Harrison/Police Station & Court Building – Design Guidance Review Meeting
Project Manager: Kelly Tayara & Ellen Fairleigh

Vincent Road Transfer Station – Conceptual Proposal Review Meeting
Project Manager: Kelly Tayara

Winslow Hotel (PLN50880 SPR CUP) – DRB Review & Recommendation Meeting

**CITY OF BAINBRIDGE ISLAND
DESIGN REVIEW BOARD – REGULAR MEETING
June 3, 2019**

Planting Plan

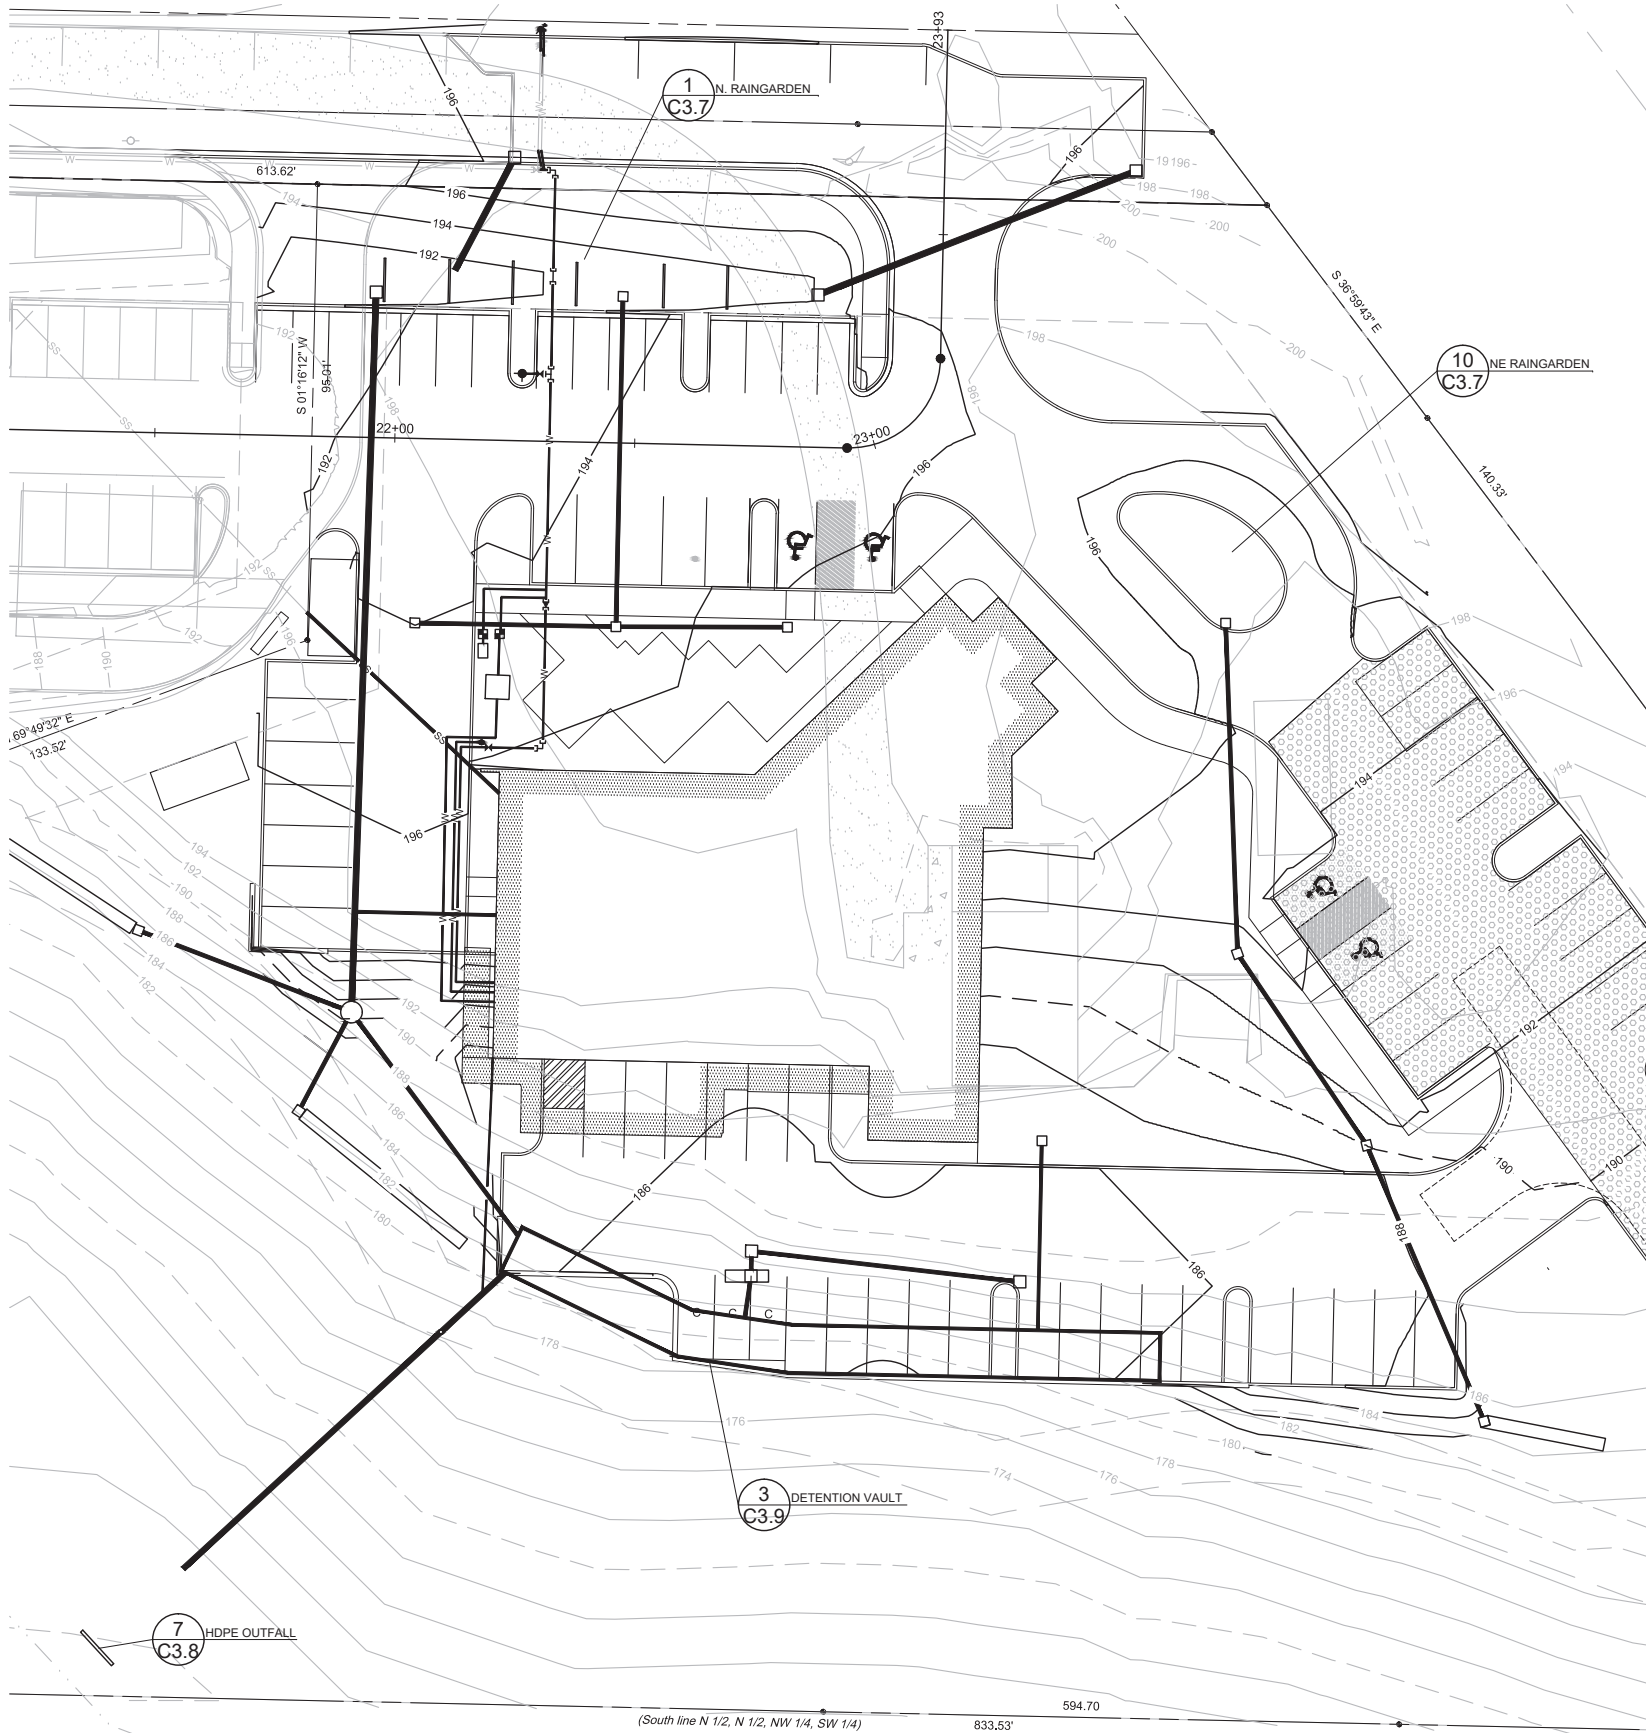
Public Comment: Resident - Concerned about the packed gravel on the landscape plan. It is difficult for manual wheelchairs to move on it. Is the packed gravel going to be in some area of the design that will require access by a wheelchair?

Applicant: The trail on landscaping plan is an existing trail that is required by the title and is not part of this project.

GROUND FLOOR
Shorter (28') West Wing
Longer (6') East Wing

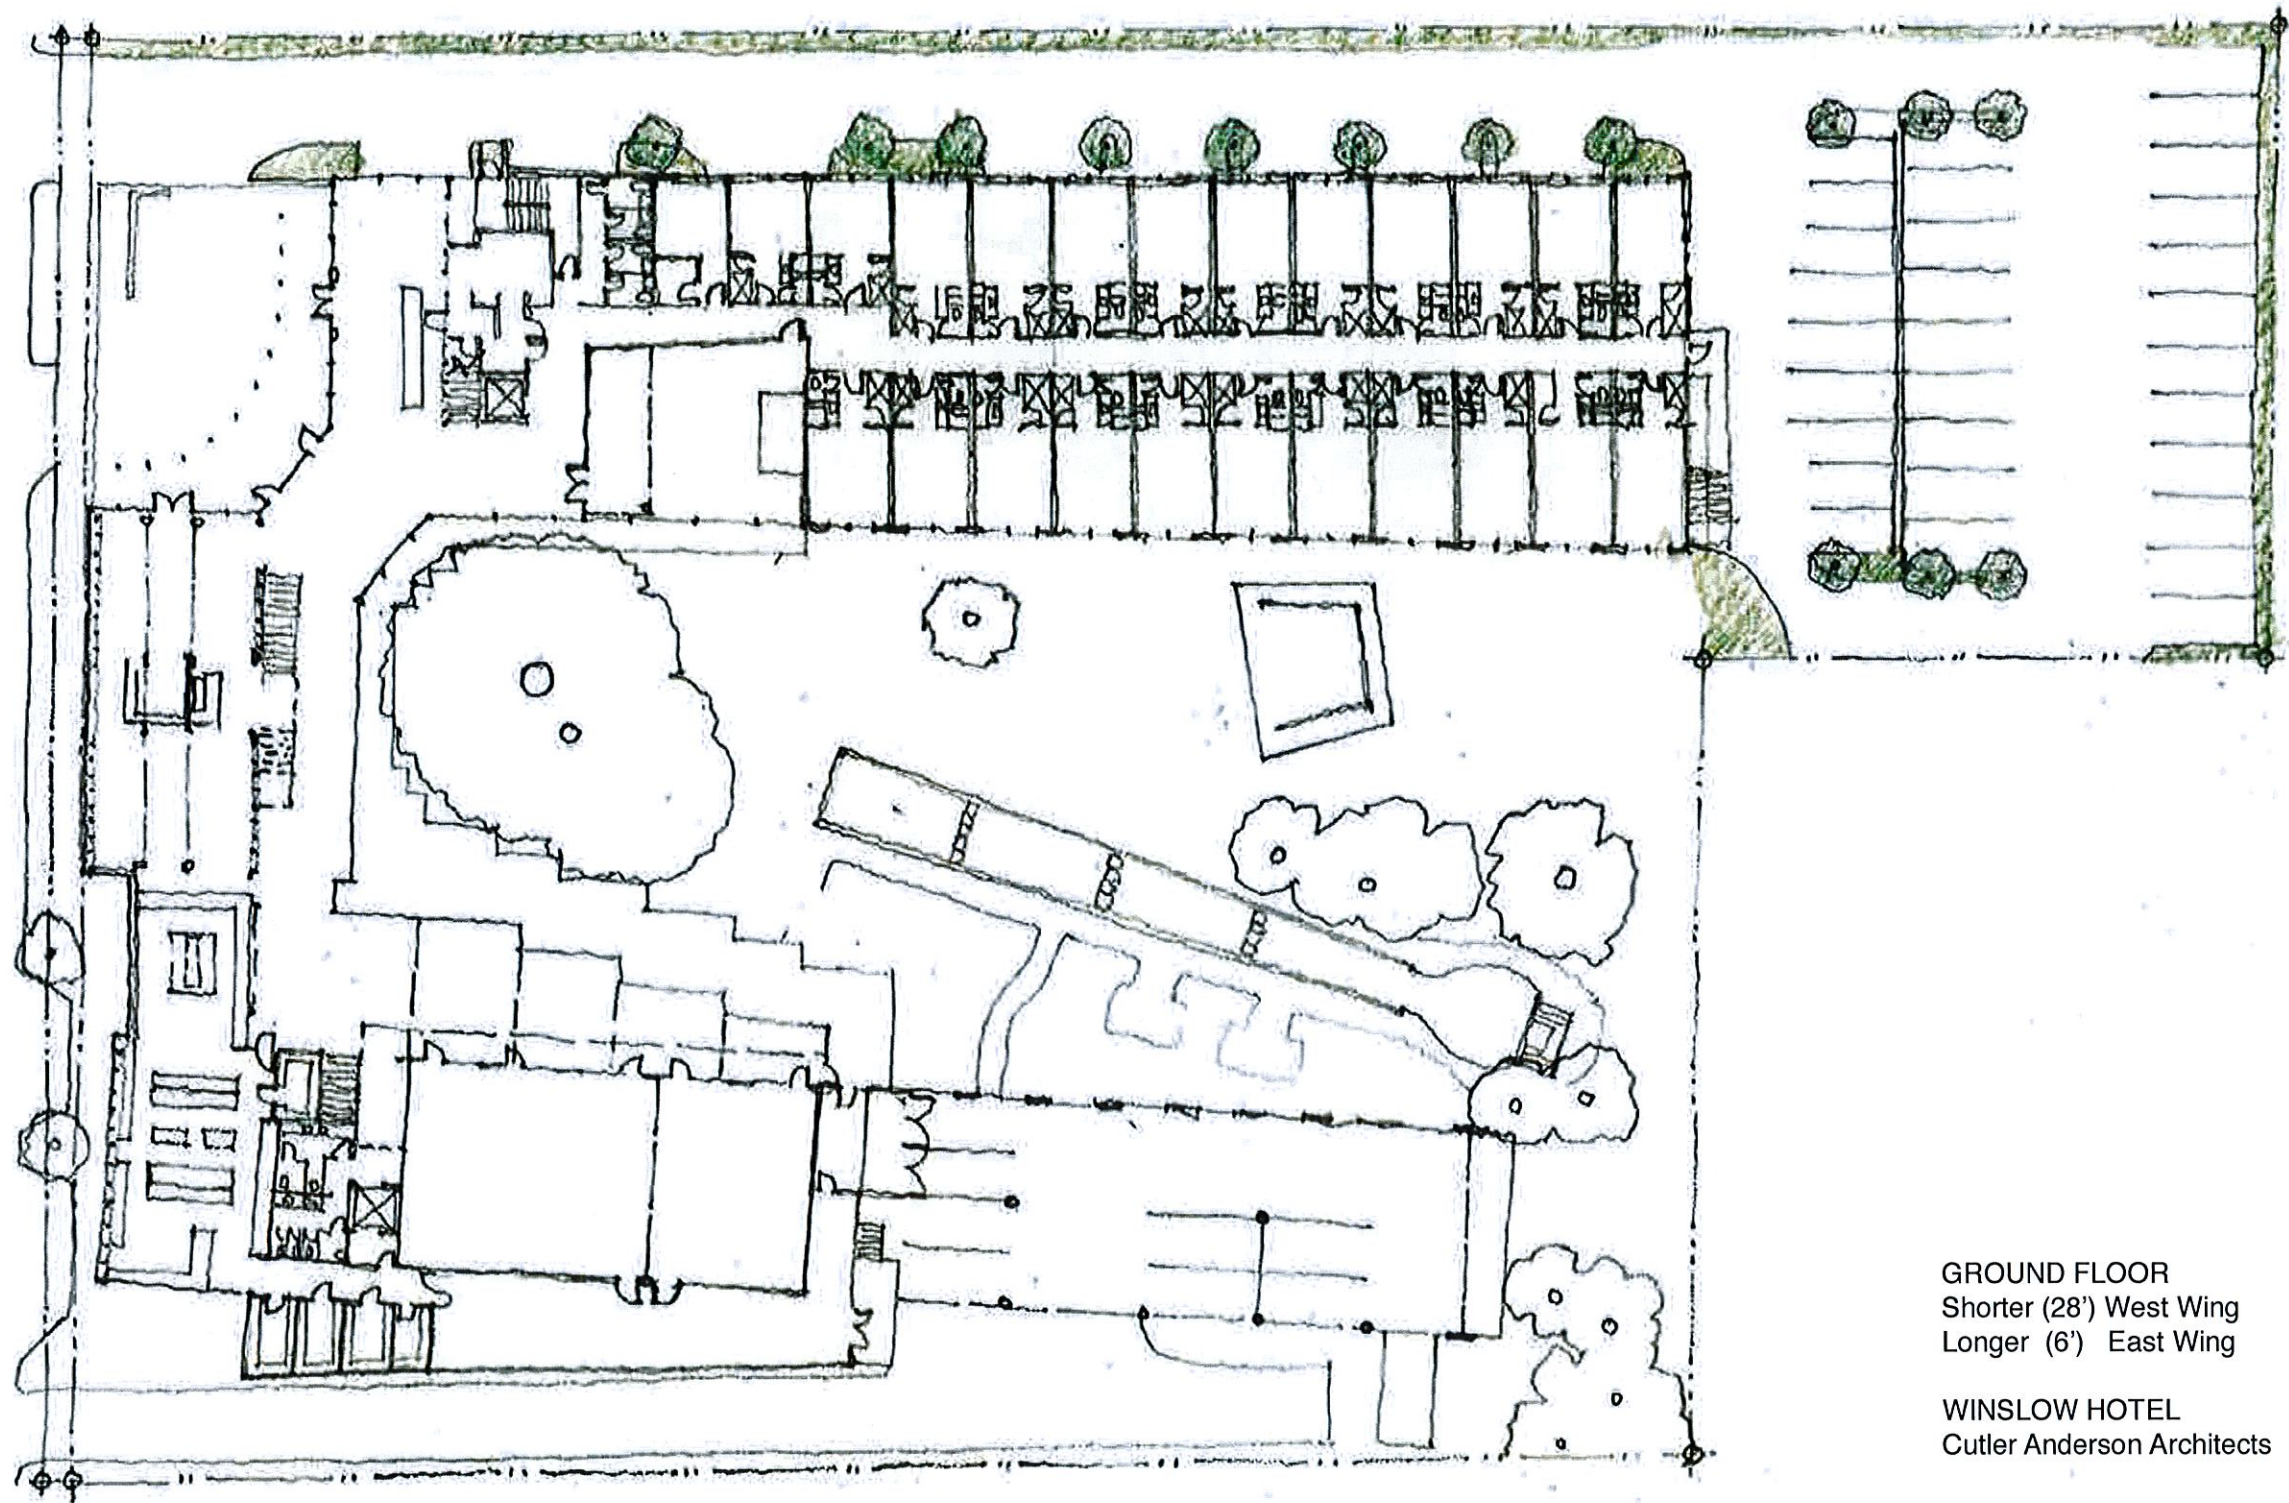
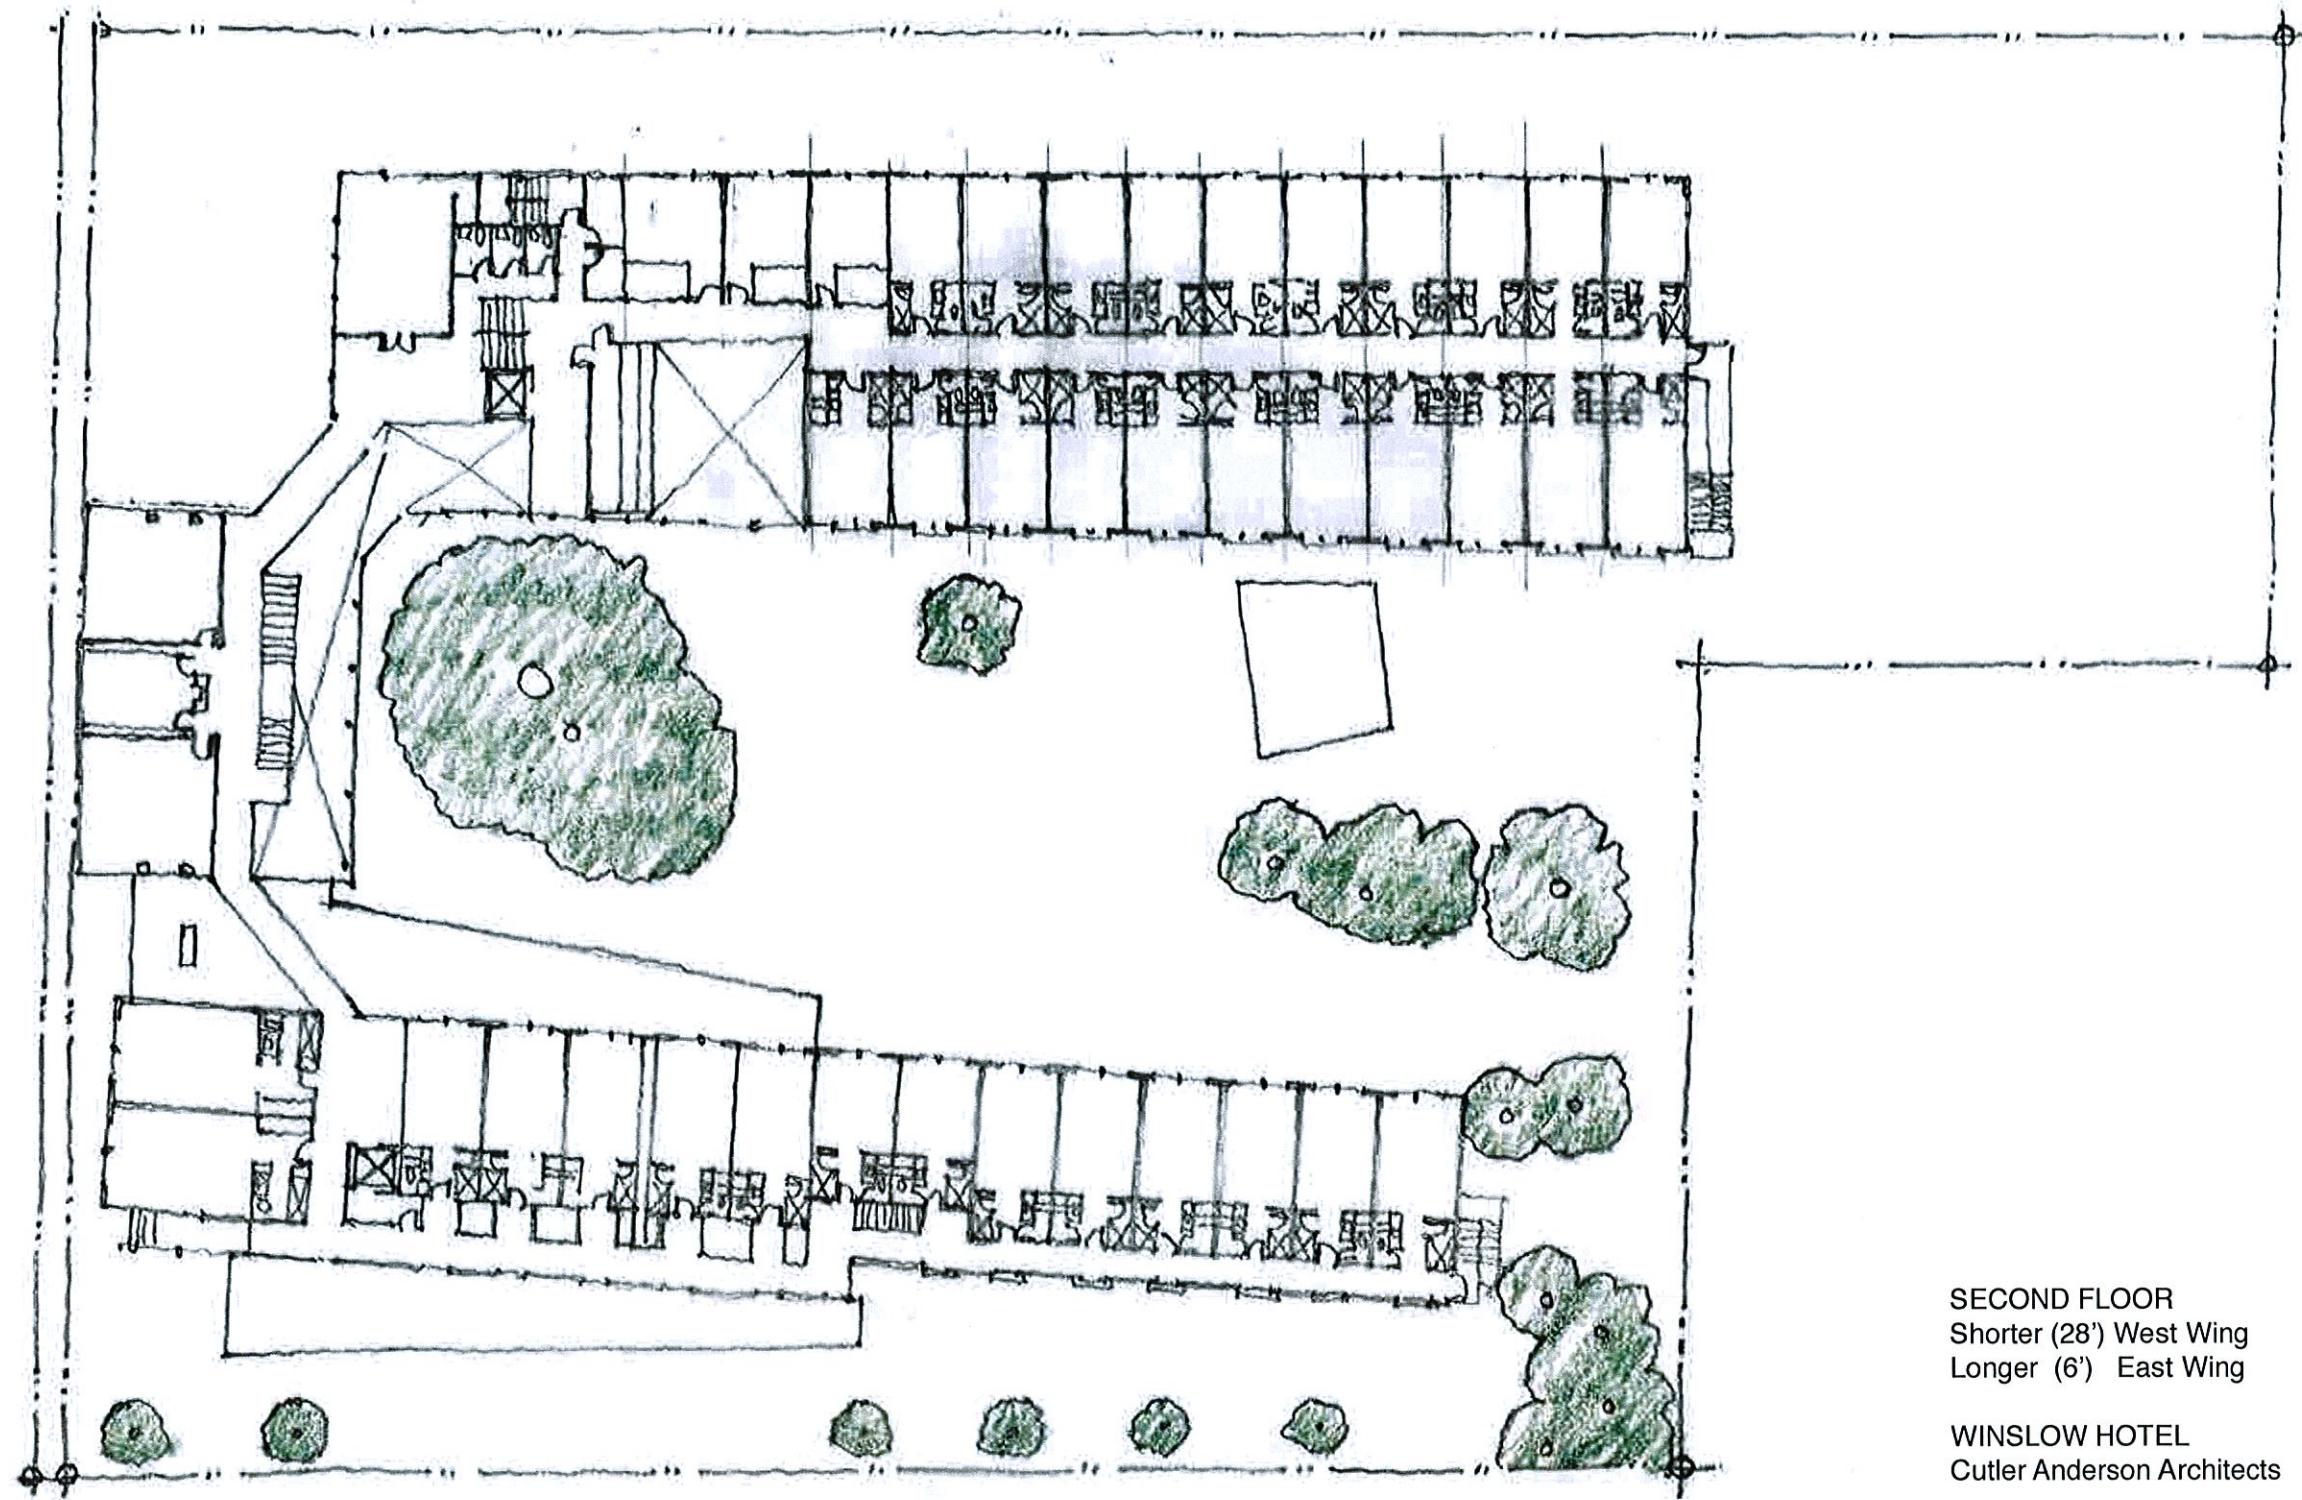
Review & Recommendation of Option 1 -

Motion: I move to recommend approval of the proposed 28-foot reduction to the west wing and 6-foot increase to the east wing.

Dunstan/No 2nd: Passed unanimously
